Concord Middle School Value Management Log Poll Results

9/14/2022

The following slides summarize the Value Management polling completed via a Google Form between Monday, 9/12/22 and Wednesday, 9/14/22 by all 13 Voting Members of the Concord Middle School Building Committee.

Item # 70: Eliminate environmental graphics (\$50K allowance) (-58,100).

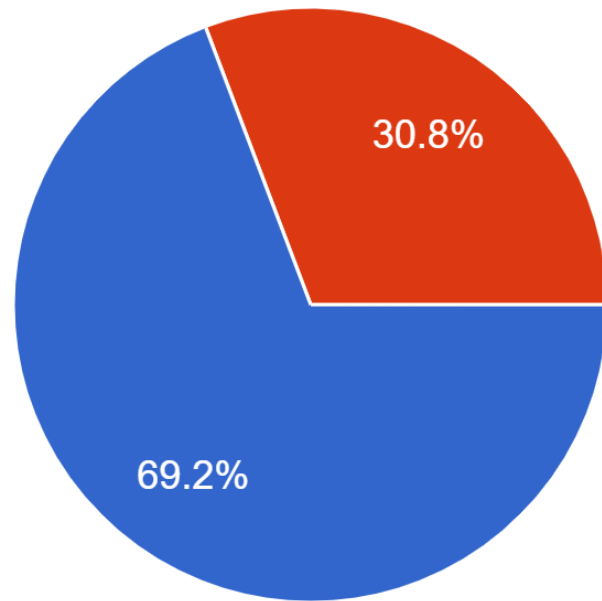
- Private funding.
- As an educational component could it be integrated into the curriculum in another way, or identify a grant to include later
- I don't know what this is, but sounds like I could support.
- Graphics are a necessary part of the overall development.
- I don't see why these need to be built into the building - you could pay an artist to do a mural later for less
- Perfect for community grants programs later

Item # 79: Replace granite bollards with concrete filled galvanized steel bollards (-126,291).

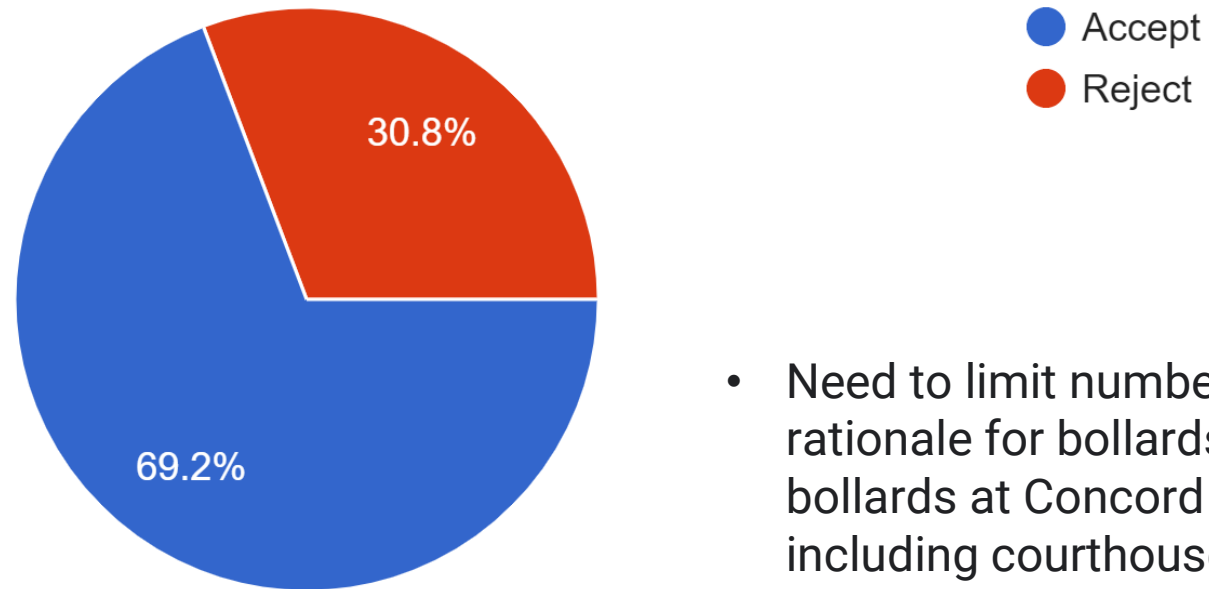
- Need to limit number of bollards. Need to understand rationale for bollards. There are very few to almost zero bollards at Concord Schools and public buildings, including courthouse.
- The school is in a highly visible primary travel corridor.
- Use stainless steel sleeved bollards instead (#79 below)
- Need more info
- Granite looks nice, but brittle and expensive; what function are we considering here?

Item #: 29: Change curtainwall and window glazing from triple to double (-438,149).

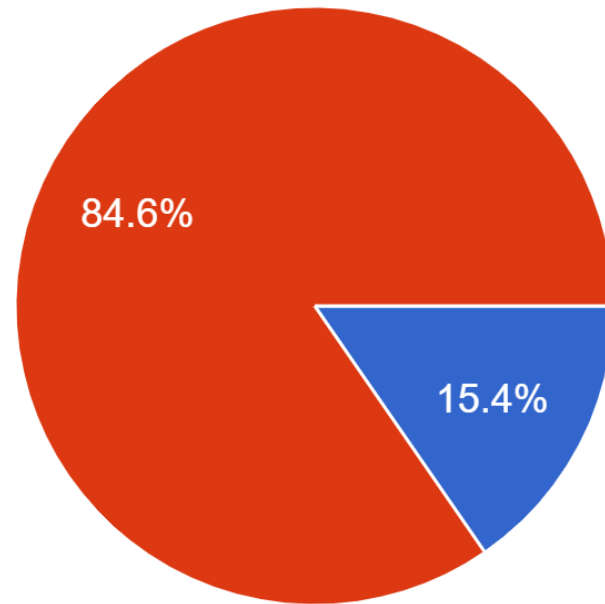
- Our commitment to town re sustainability
- I believe that this would prevent us from meeting our obligations to create a net-zero building, which were voted at special town meeting
- I don't support any cuts that will reduce energy efficiency or increase maintenance costs
- Is this savings estimate only the cost delta between double and triple glazing. Does SMMA foresee any cost increases, like with MEP, because of this change?

Item # 45: Exterior Wall Assemblies: Install Metal Composite material wall panels in lieu of phenolic: available products that may be incorporat....; ALOCTEX Inc Alcotex, FR.; Or equal. (-34,703).

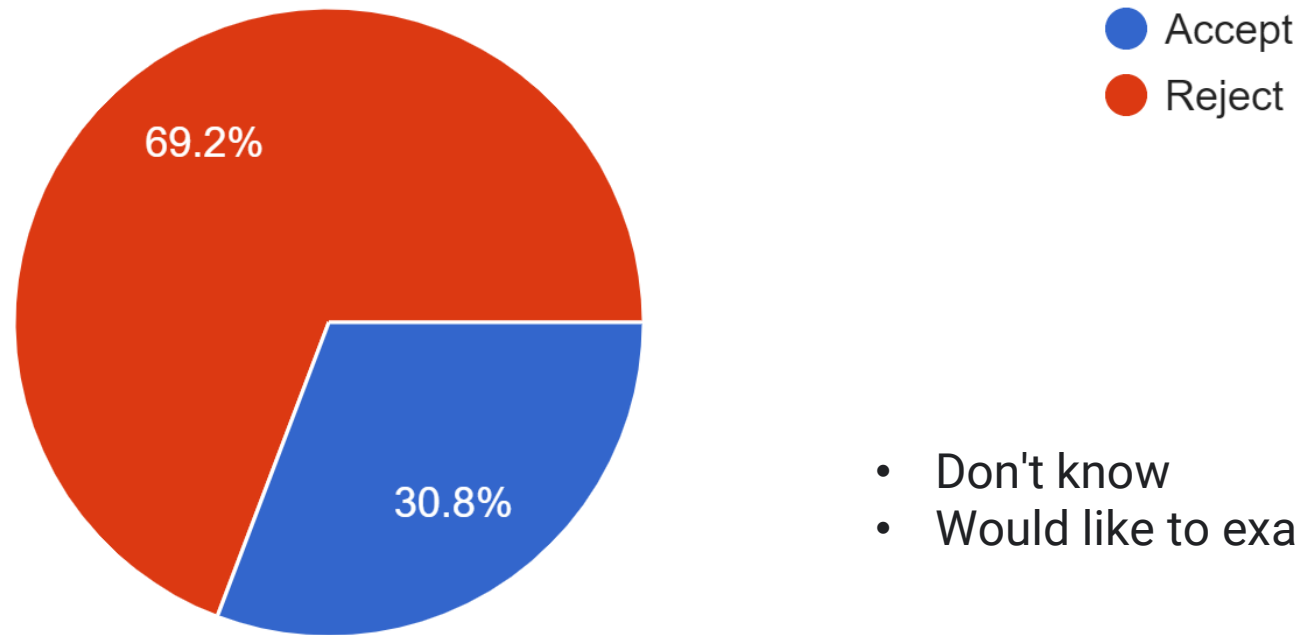
- Don't know
- Would like to examine alternatives more closely

Item # 50: Replace folding glass walls at Classrooms into Commons with hollow metal frames and glazing (Maintain folding glass wall at Media Center) (-113,431).

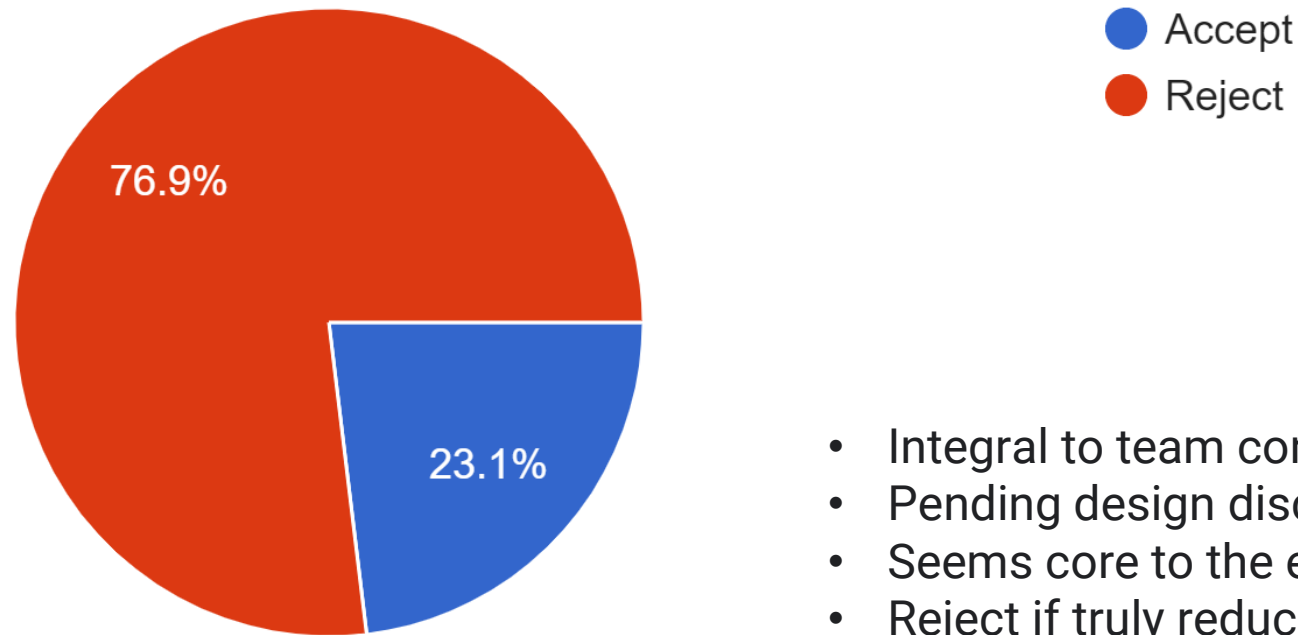
- Integral to team concept
- Pending design discussion, this may be wise
- Seems core to the educational plan
- Reject if truly reduces functionality of team set-ups

Item # 52: Eliminate stair access to roof- reduce height of stair tower, add alternating tread stair and hatch for roof access (-143,403).

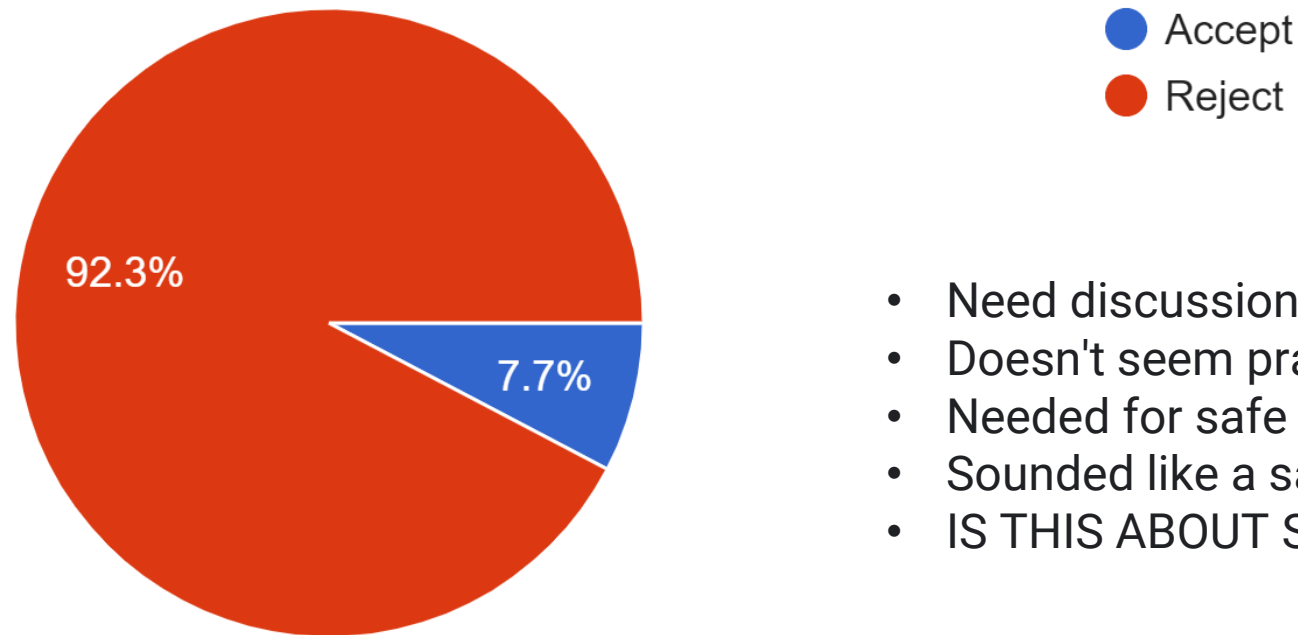
- Need discussion. Need to see item 52 proposal.
- Doesn't seem practical in long run
- Needed for safe access to roof equipment.
- Sounded like a safety concern
- IS THIS ABOUT SAFETY OR CONVENIENCE?

Item # 56 Remove 8' tall mesh front storage cabinets at Team Commons (-69,750).

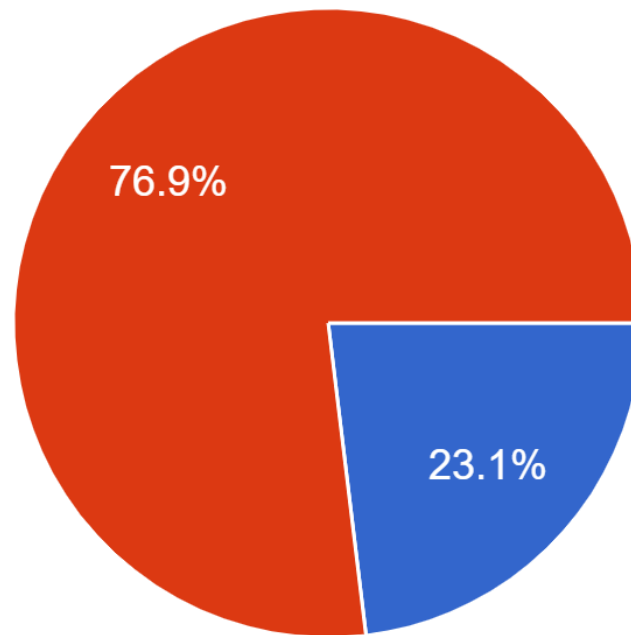
- I need more info on this one
- Storage is always an issue
- Reject if its the only place for student gear

Item # 59: Eliminate unit skylights in Admin area (-23,990).

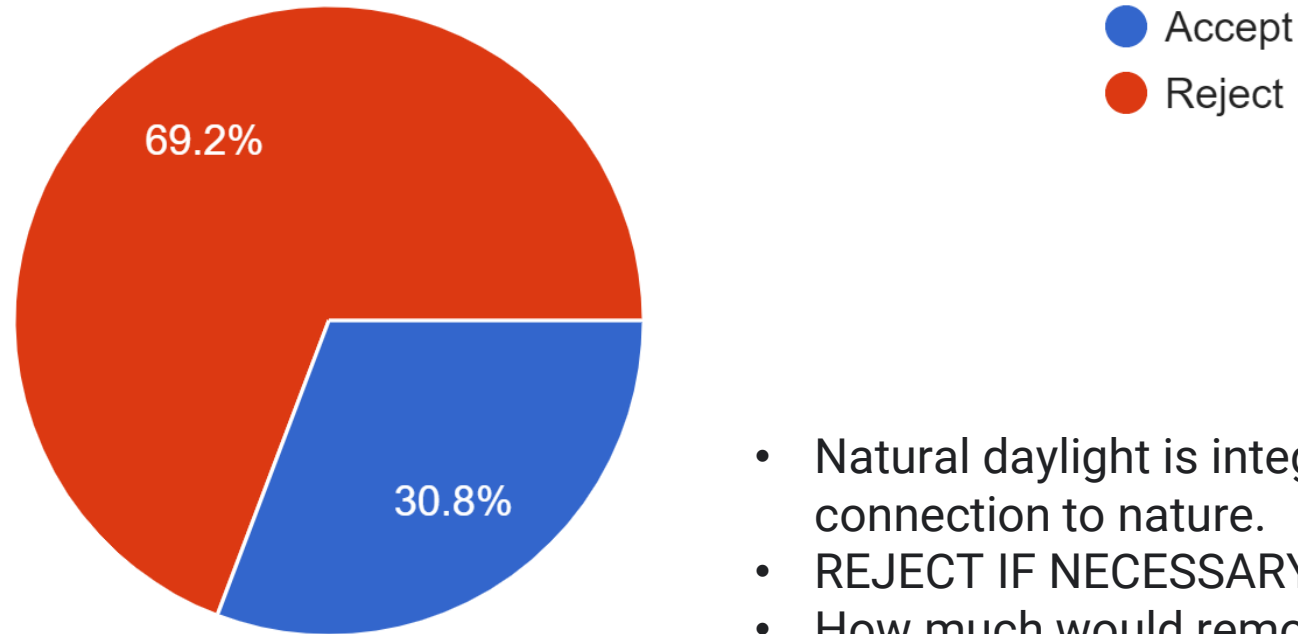
- Natural daylight is integral to providing a sense of connection to nature.
- REJECT IF NECESSARY TO BUILD TO BUDGET
- How much would removing skylights impact daylighting in the space?

Item # 62: Eliminate Phase 2 existing building demo and abatement scope (-1,985,945).

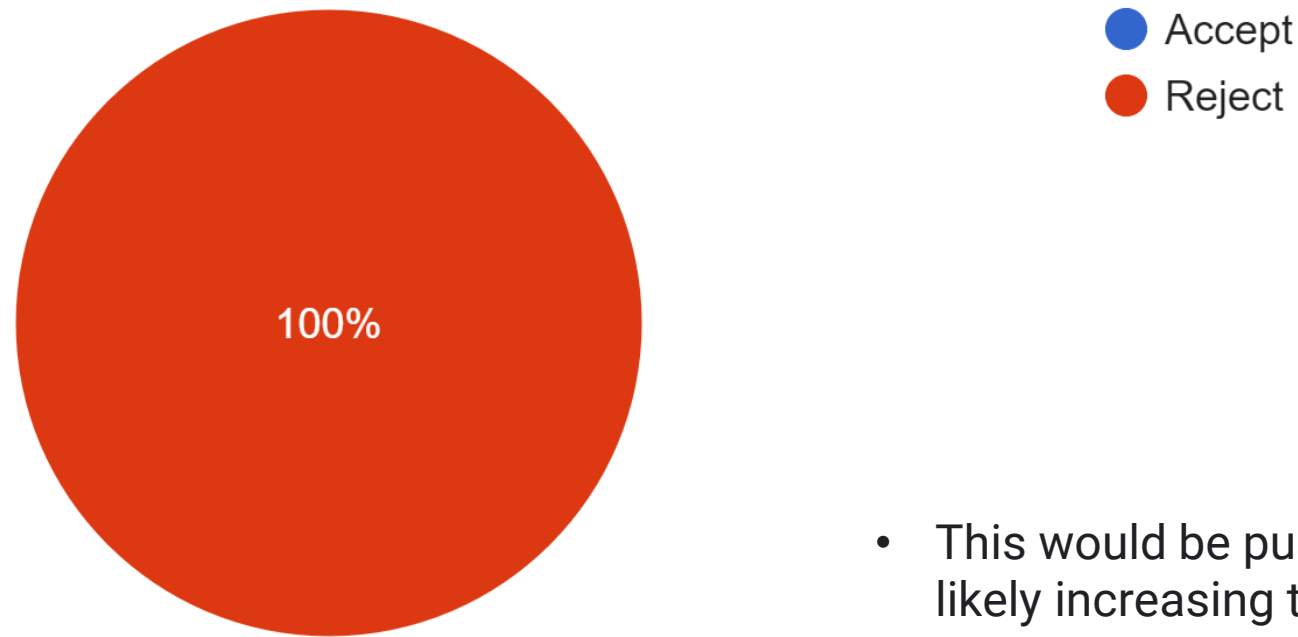
- This would be pushing the costs to later, thus likely increasing them, which would be irresponsible.
- Not realistic option

Item # 65: Replace linoleum with VCT (-169,719).

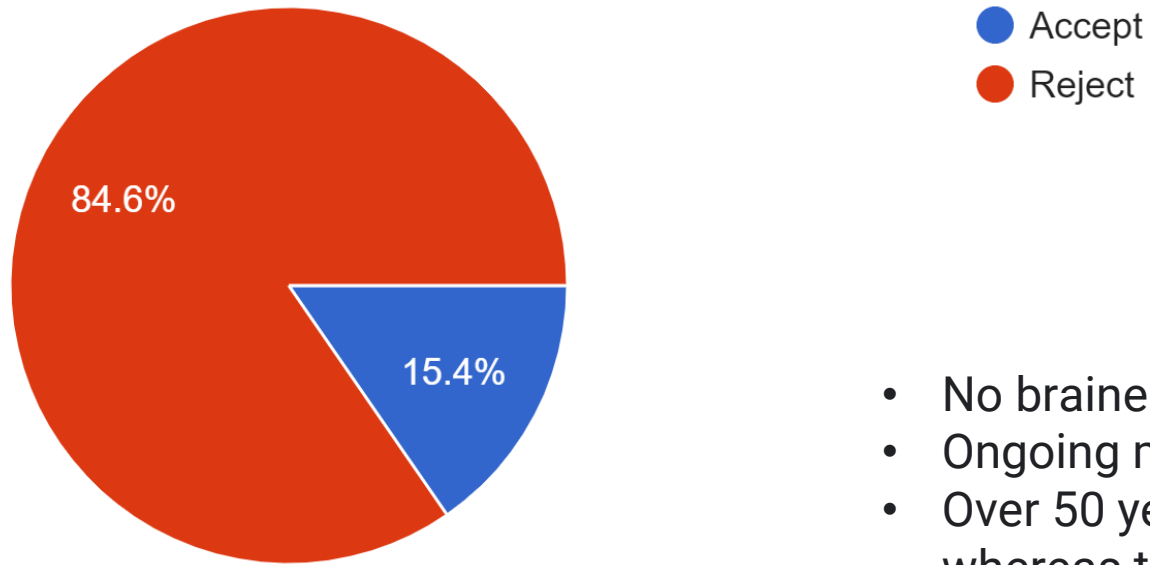
- No brainer.
- Ongoing maintenance costs
- Over 50 years linoleum may need replacement whereas the VCT could potentially survive with proper maintenance.
- Maintenance tradeoff doesn't sound worthwhile for this one.
- Need more info
- Cost offsets with future maintenance

Item # 68: Remove (2) maintenance sheds at loading dock- provide conduit and electrical stub up and concrete pads only (-17,452).

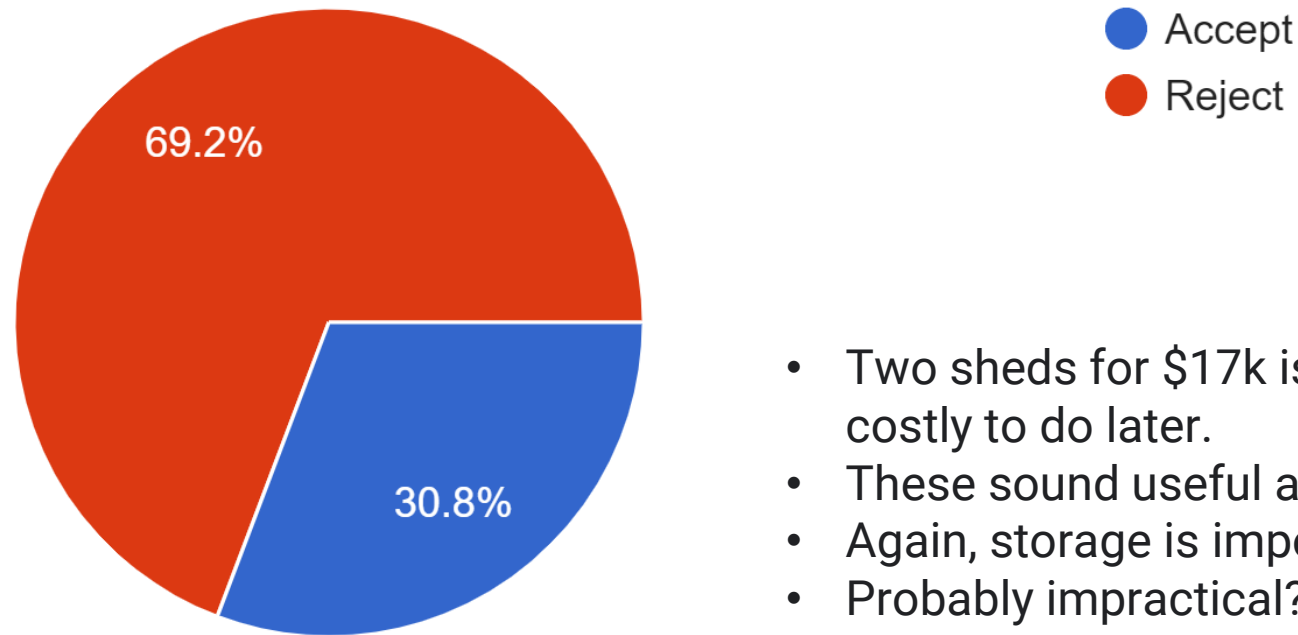
- Two sheds for \$17k is a bargain. This will be more costly to do later.
- These sound useful and cost-effective
- Again, storage is important
- Probably impractical? let's examine this
- Russ' feedback on this item would be helpful.

Item # 71: Eliminate bleachers in the Gymnasium (possibly provided by donation?) (-84,240).

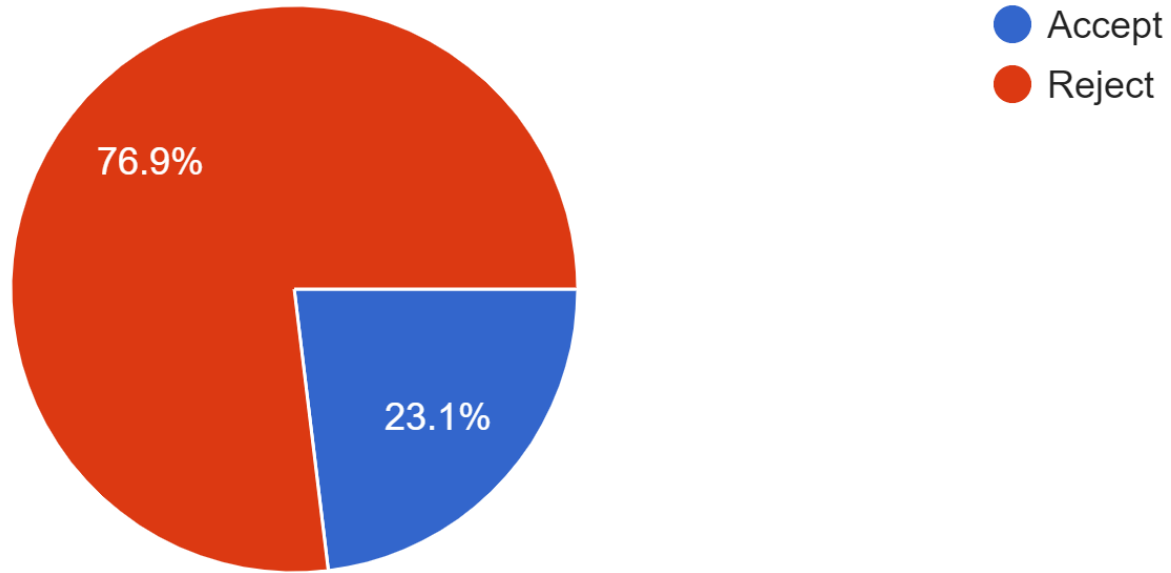
- Seems like a reasonable thing to find donors... I assume if we reduce the size of the gym.
- Fee-based users could help benefit their cause

Item # 72a: Eliminate all millwork display cases (-\$154,752).

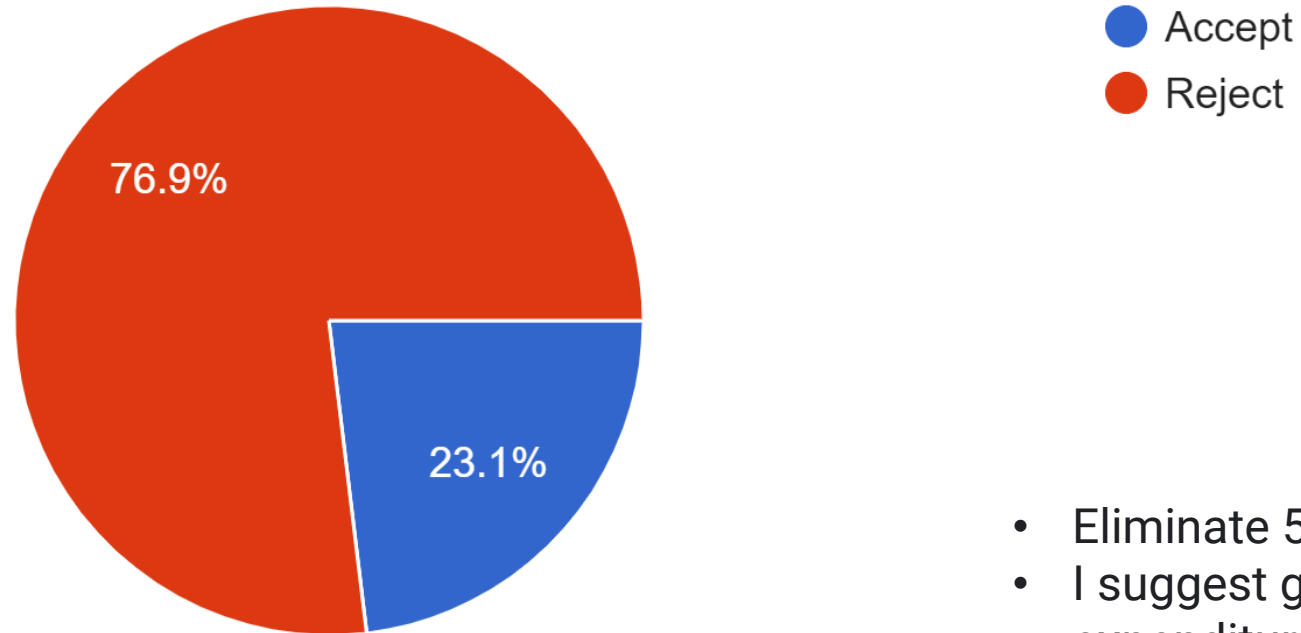
- Eliminate 50%
- I suggest going with the 50% millwork expenditure item below
- OR! reduce by 50%

Item # 81: Reduce size of Gymnasium by 3,500 Square Feet to MSBA Standard (6,000 SF Gym with MIAA Court) (-1,213,750).

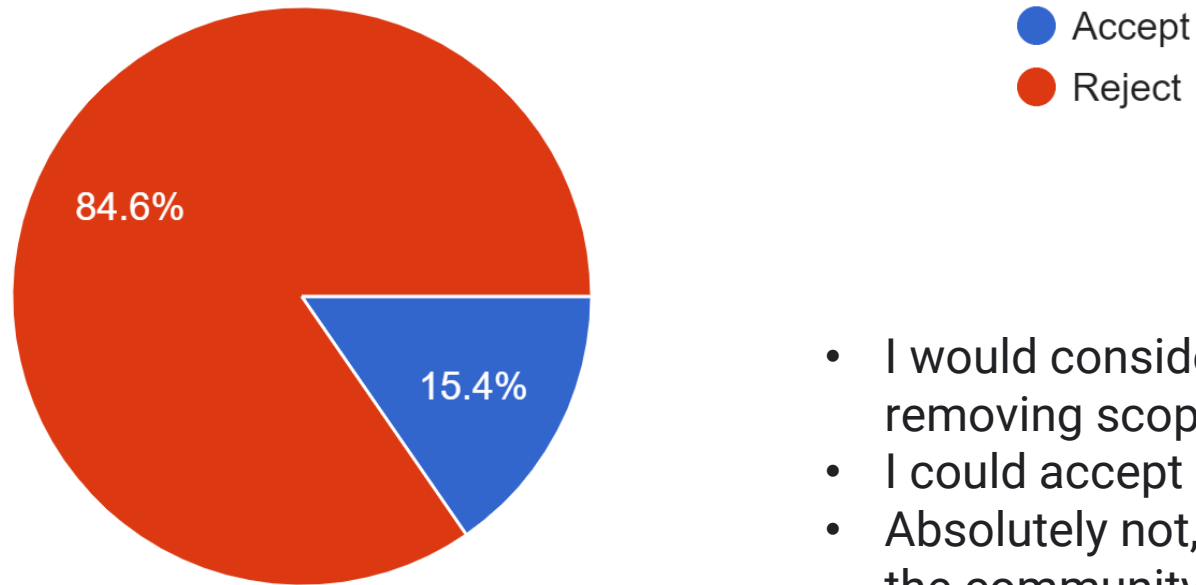
- I would consider as a last resort prior to removing scope from academic Ed Plan spaces
- I could accept a smaller gym, but not 6000 sq ft
- Absolutely not, we've heard loud and clear from the community not to cut this space
- we can reduce height before we reduce size; reduce AV extras
- Put in sperate bucket with auditorium for town vote

Item # 82: Reduce size of Auditorium to accommodate 270 person occupancy; reduce by 1/3 from 5040 SF to 3240 SF (-670,000).

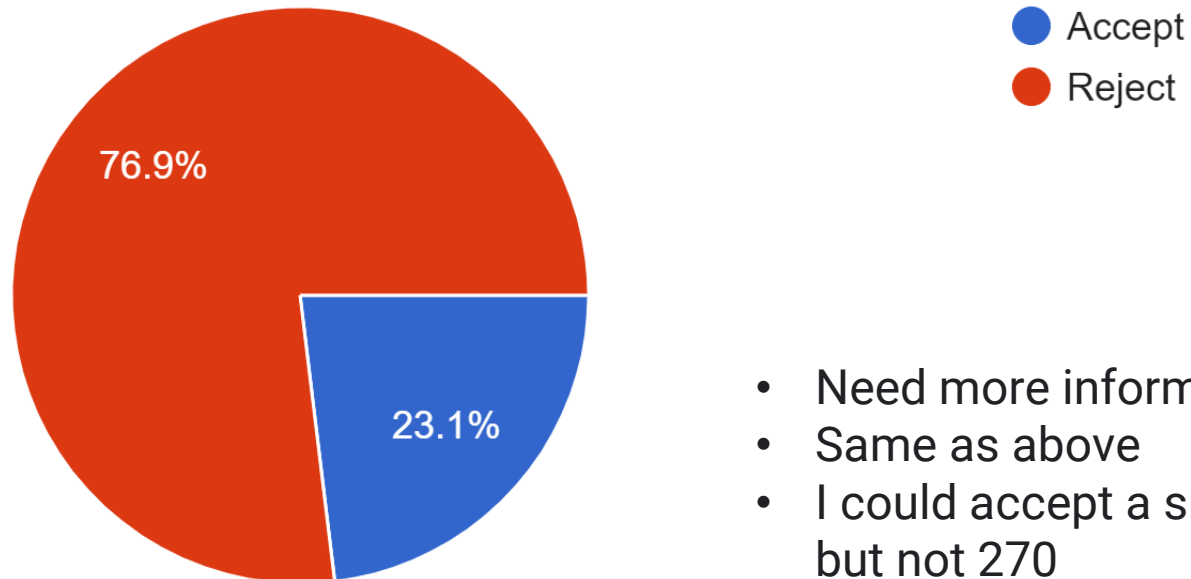
- Need more information
- Same as above
- I could accept a smaller auditorium (maybe 350 seats) but not 270
- Ditto - above
- Painful, but consistent with sizing relative to overall population in all other schools
- Put in sperate bucket with gym reduction for town vote
